NRC Staff Comments on FAQ 10-0059, Revision 0 [HTB] {April 2011}
DRAFT

FAQ Number 10-0059 FAQ Revision Rev. 0
FAQ Title NFPA 805 Monitoring

Plant: Harris Nuclear Plant **Date:** February 17, 2011

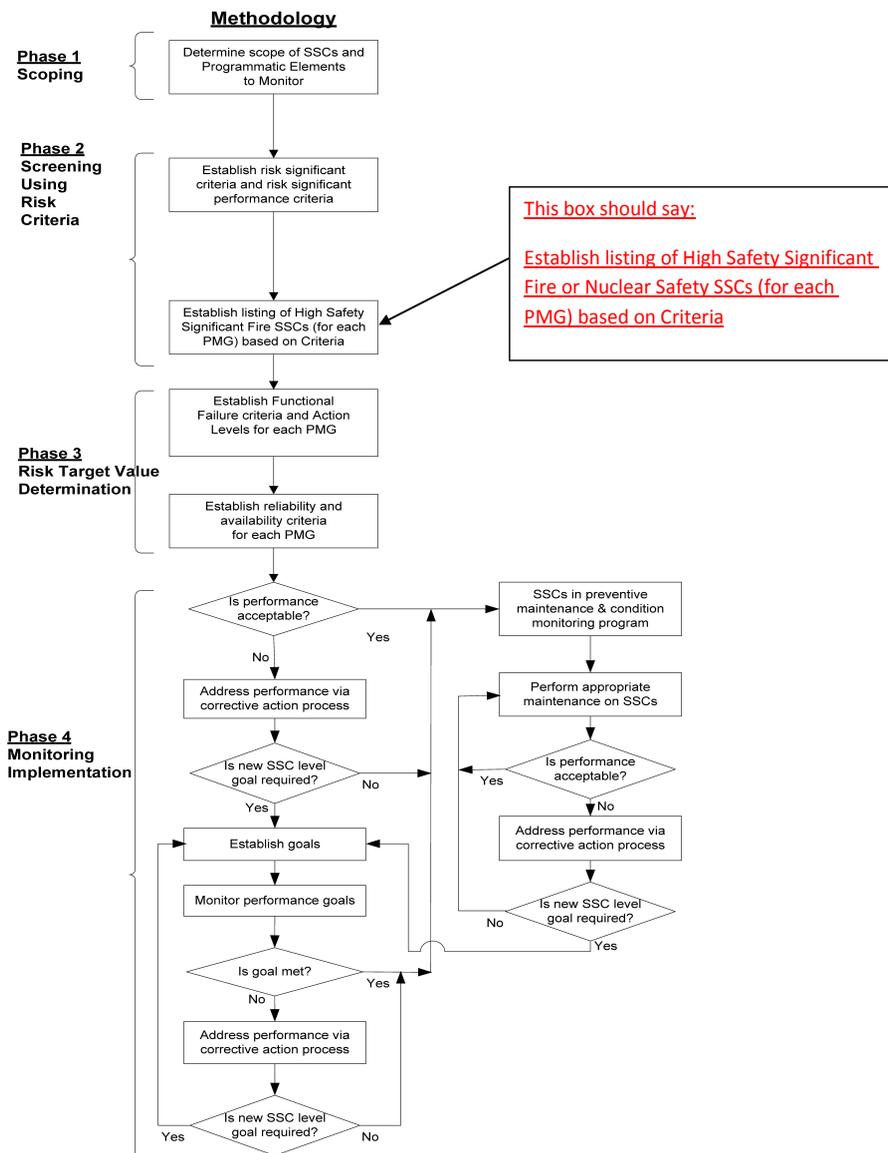
This box should say:
 Establish listing of High Safety Significant Fire or Nuclear Safety SSCs (for each PMG) based on Criteria
